BCA ASSESSMENT REPORT

Building 2B, Oakdale West Estate

SSD 7348 Mod3 & SSD 10397 Stage 2 DA

Revision 3

Figure 1 – Perimeter Vehicular Access per BCA C2.4.

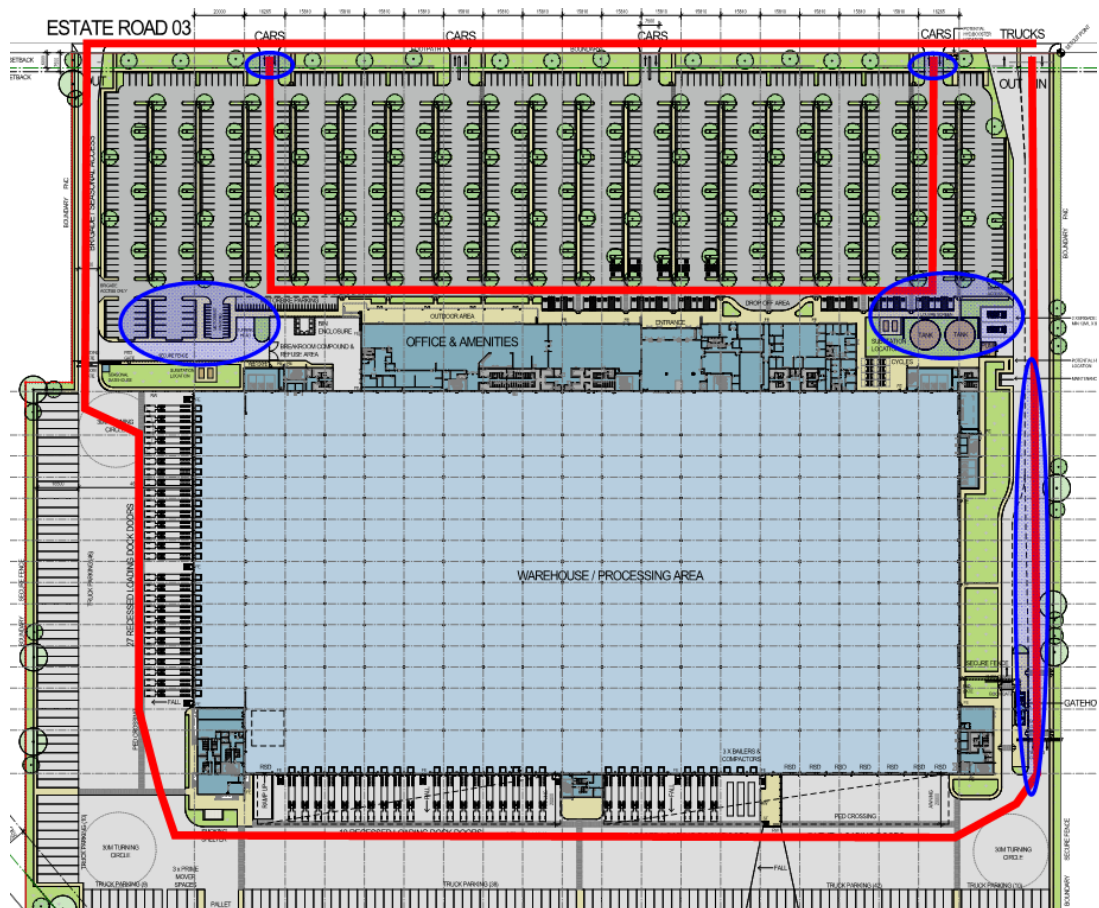
Comments: The proposed warehouse building complies with the provisions of C2.4 with the exception of the areas circled in blue on the mark-up below that are required to be addressed as a performance solution by the Fire Safety Engineer:

- + Vehicular Access is greater than 18m from the external wall of the Building along the northern elevation and in the NW & SW corners of the site.
- + Vehicular Access is discontinuous in the NW & SW corners of the building.
- + Vehicular Access via the Staff Carpark on the Western side of the building is not likely to comply with the FRNSW Policy 4 vehicular access guidelines and the width of the entries to the carpark will be less than 6m.
